GENWAL COAL COMPANY

RE: Permit # ACT 007-012
Castle Valley Resources
Permit Modification

Castle Valley Resources requests an amendment to allow disposal of non-hazardous waste from Genwal Coal Companies mine located in Crandal Canyon. This amendment would allow a one time exemption to allow for temporary storage of approximately 600 cys of material.

Dwg No. 4067-G-10A

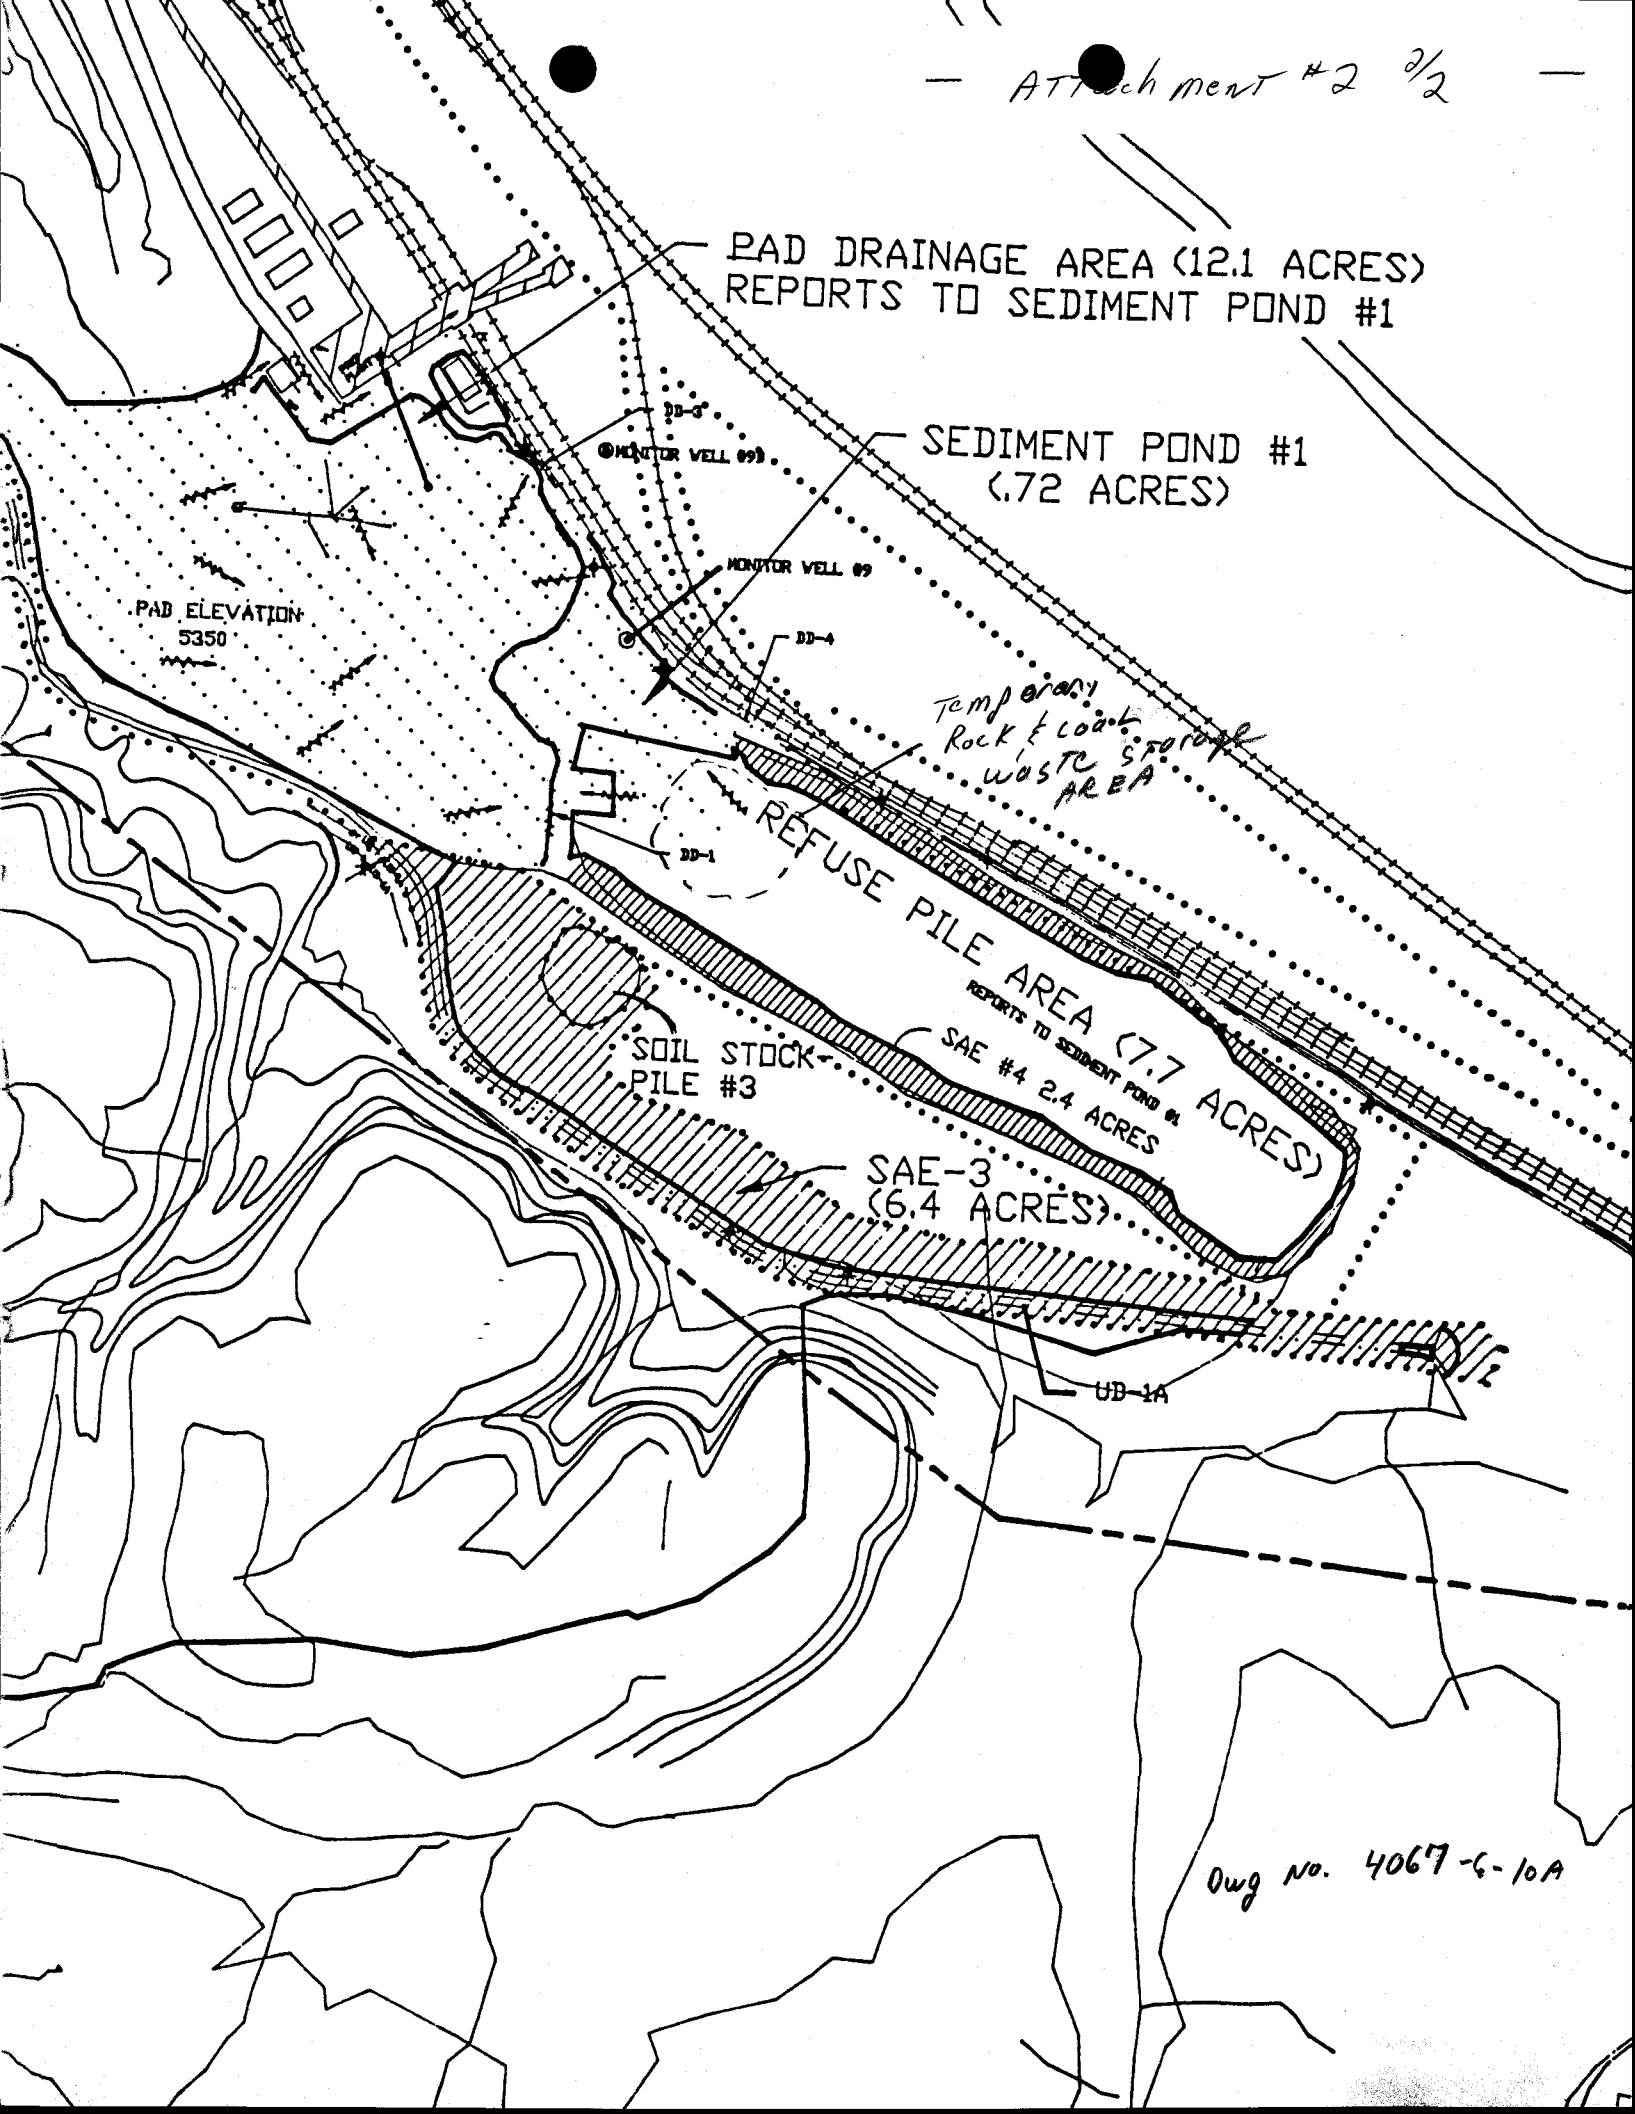
The material will be placed on the northeast side of the refuse pile. (see attached drawing 4067-6-10A) All runoff from the pile will report to sediment pond #1. The temporary storage area will not result in any additional disturbance.

Straw Bale Filter Dam

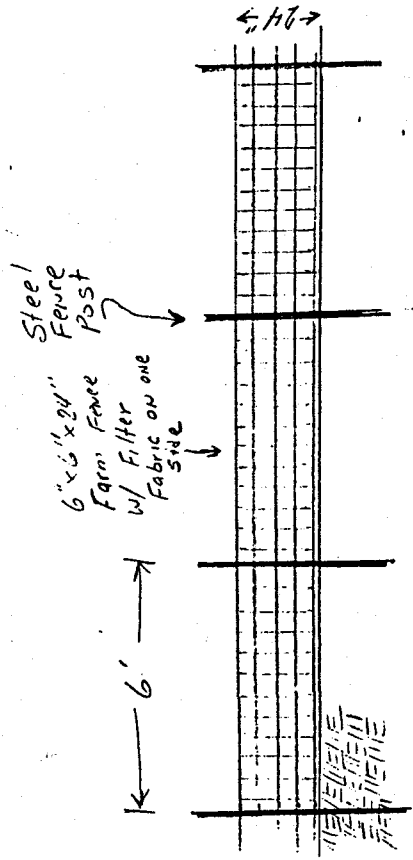
We plan to place a temporary silt Catch Fence underneath (south) of Hilfiker Retaining Wall and (north) or above the creek, between STA 25+00 and STA. 26+00 of the Road Plan sheet 2. Also we will place 2 each filter dams made of straw bales, down stream on the creek. See attached map for locations and typical section view of attached plan for the silt Fence and straw filter dams.
